Subject: VIRGIL C. SUMMER NUCLEAR STATION (VCSNS) UNIT 1
DOCKET NO. 50-395
OPERATING LICENSE NO. NPF-12
RESPONSE TO NRC REQUEST FOR ADDITIONAL INFORMATION
REGARDING SEISMIC EVALUATIONS RELATED TO SOUTHEASTERN
CATALOG CHANGES

**Enclosure
Senior Seismic Hazard Analysis Committee (SSHAC) Level 2 Review**

April 23, 2015

Figure 16: Seismicity with $E[M] \geq 2.9$ occurred within 100 km of the Oconee NPP from 1968 through December 2007: a) from Rev 7 of the CEUS-SSC earthquake catalog; b) from Rev 8.

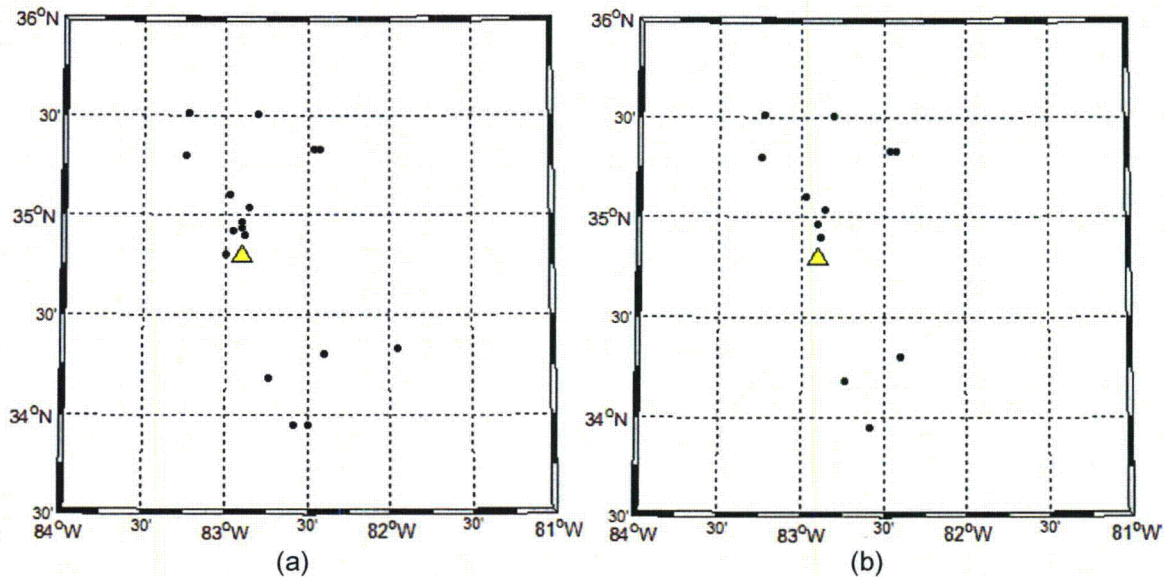
Figure 1 shows that the events in Table 4 are located in proximity of two NPPs: Oconee and VC Summer. The earthquakes located within 100 km of each NPP were plotted and analyzed to identify any other cluster of seismicity of non-tectonic origin. Figure 16 compares the earthquakes with $E[M] \geq 2.9$ that occurred from 1968 to December 2007, located within 100 km of the Oconee NPP, from Rev 7 of the CEUS SSC Catalog (Figure 16a) and from Rev 8 (Figure

16b). The comparison indicates that the analysis presented in this report has removed several earthquakes that had previously been used to calculate recurrence rates for PSHA.

Figure 17: Seismicity with $E[M] \geq 2.9$ occurred within 100 km of the VC Summer NPP from 1968 through December 2007: a) from Rev 7 of the CEUS-SSC earthquake catalog; b) from Rev 8.

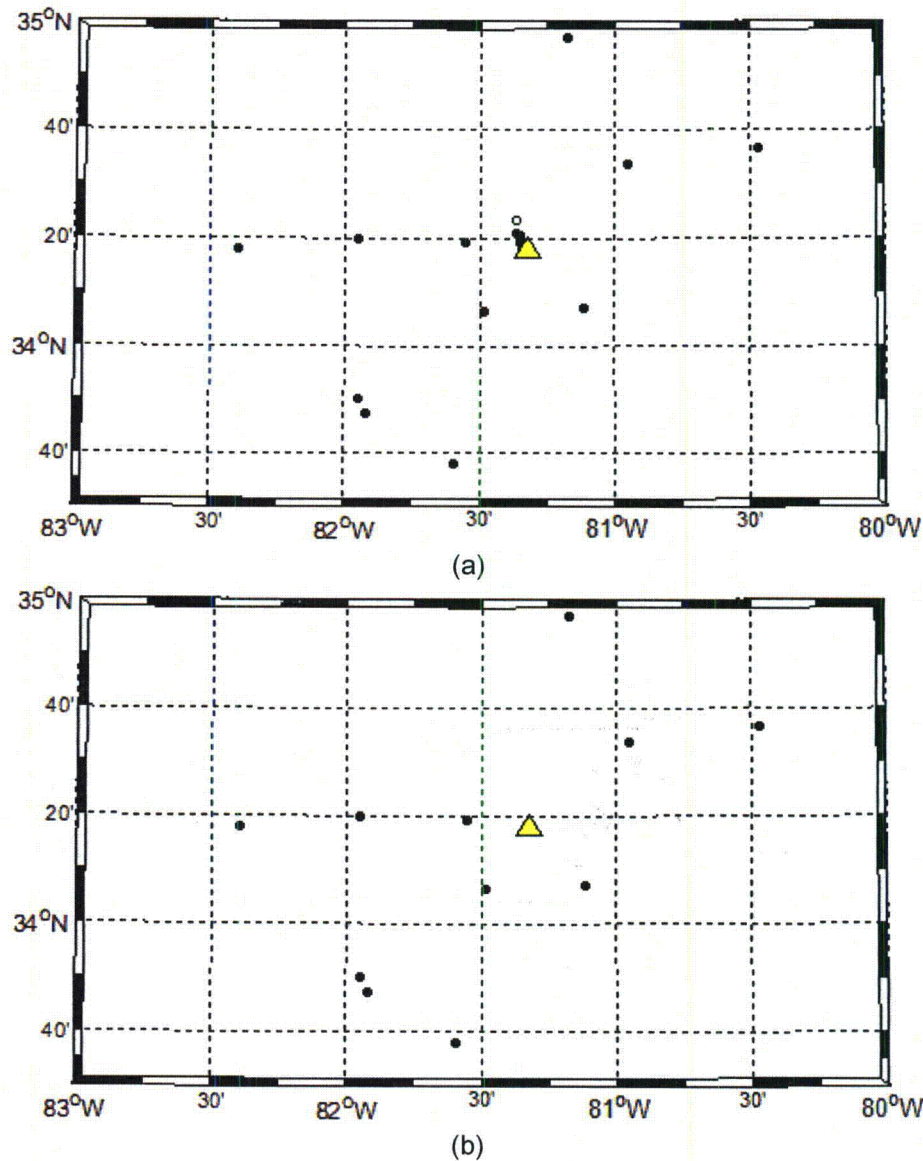
Figure 17 shows a similar comparison for the seismicity within 100 km of the VC Summer NPP: Figure 17a shows the earthquakes in Rev 7 of the catalog with $E[M] \geq 2.9$ occurred from 1968 to December 2007; Figure 17b shows the earthquakes from Rev 8 of the catalog. The cluster of earthquakes associated with the Monticello Reservoir has been effectively removed from the earthquake catalog in Rev 8.

Figure 18: Isoseismal map for January 19, 1860 earthquake provided by Donald Stevenson and Dr. Predeep Talwani (written communication, February 19, 2014).

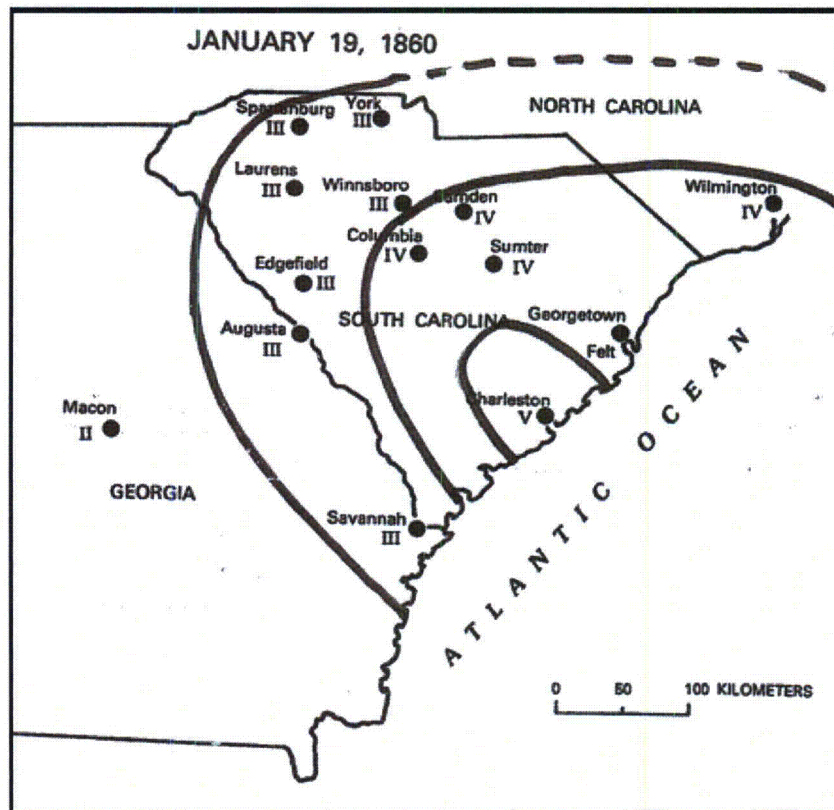
The location in the Rev 7 catalog is based on NCEER-91. Donald Stevenson and Dr. Predeep Talwani provided the isoseismal map shown below based on their interpretation of the available intensity data. This interpretation suggests a location near Charleston. The recommendation is to utilize the Charleston location given in the SUSN catalog.

Figure 20: Comparison of ln(FA)-I₀ data for Category 4 Earthquakes from Seeber and Armbruster (1987) with data from other earthquakes from the CEUS SSC Rev 7 catalog.

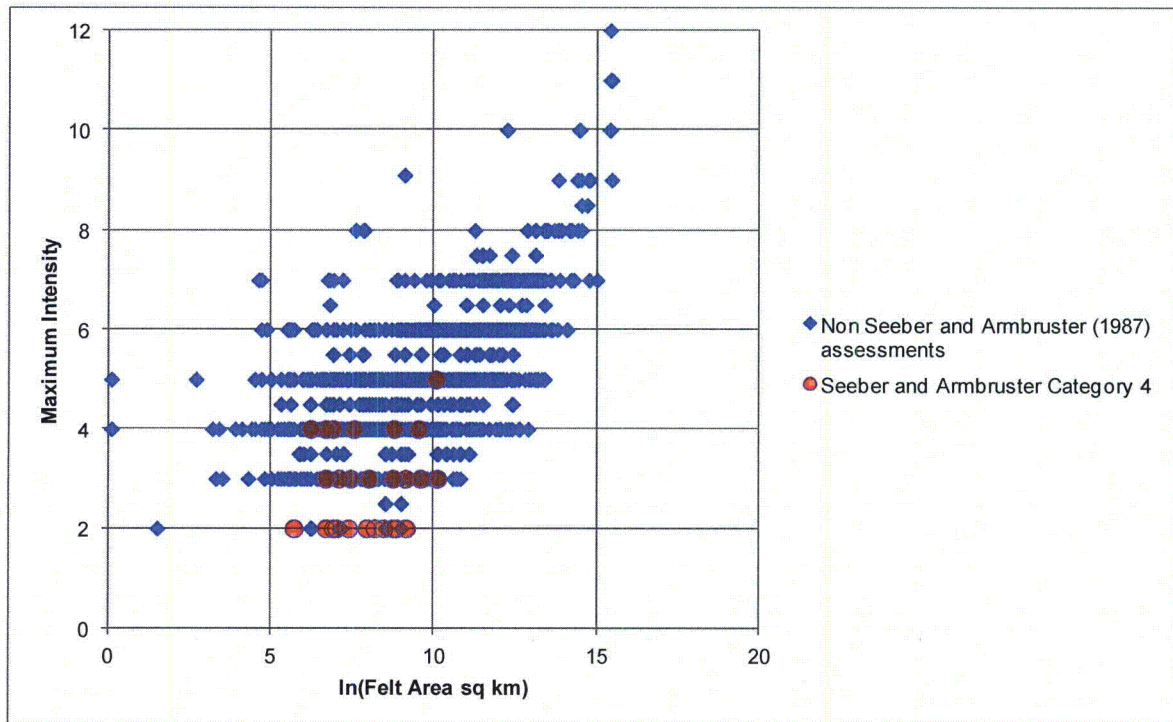
Although this event was listed as a category 4 earthquake in Seeber and Armbruster (1987), it was not carried forward into NCEER-91. Also the $\ln(FA)$ of 8.46 is anomalous compared to the I_0 of II (Figure 20). The recommendation is to not use the felt area reported by Seeber and Armbruster (1987), which will result in the event not being considered in estimation of earthquake recurrence.

Although this event was listed as a category 4 earthquake in Seeber and Armbruster (1987), it was not carried forward into NCEER-91. Also the $\ln(FA)$ of 8.92 is anomalous compared to the I_0 of II (Figure 20). The recommendation is to not use the felt area reported by Seeber and Armbruster (1987), which will result in the event not being considered in estimation of earthquake recurrence.

Figure A2 comparison of $\ln(\text{FA})$ - I_0 data for Category 4 Earthquakes from Seeber and Armbruster (1987) with data from other earthquakes from the CEUS SSC Version 7 catalog.

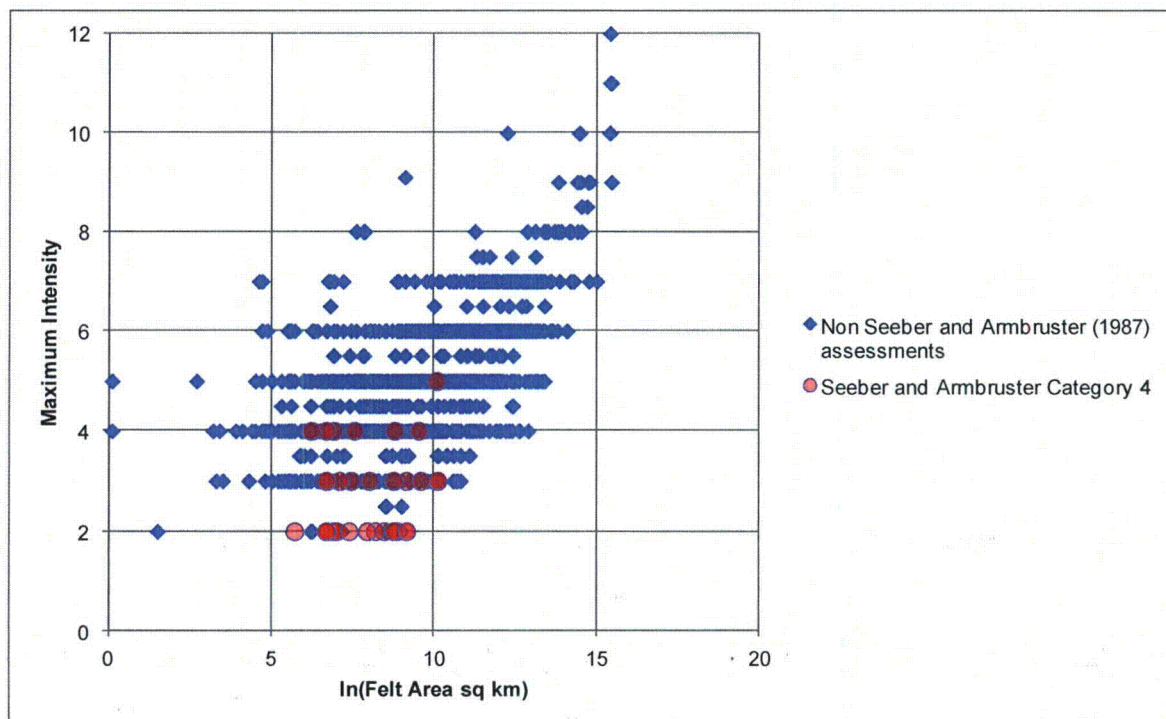
Although this event was listed as a category 4 earthquake in Seeber and Armbruster (1987), it was not carried forward into NCEER-91. Also the $\ln(FA)$ of 8.46 is anomalous compared to the I_0 of II (Figure A2). The recommendation is to not use the felt area reported by Seeber and Armbruster (1987), which will result in the event not being considered in estimation of earthquake recurrence.

Although this event was listed as a category 4 earthquake in Seeber and Armbruster (1987), it was not carried forward into NCEER-91. Also the $\ln(FA)$ of 8.92 is anomalous compared to the I_0 of II (Figure A2). The recommendation is to not use the felt area reported by Seeber and Armbruster (1987), which will result in the event not being considered in estimation of earthquake recurrence.
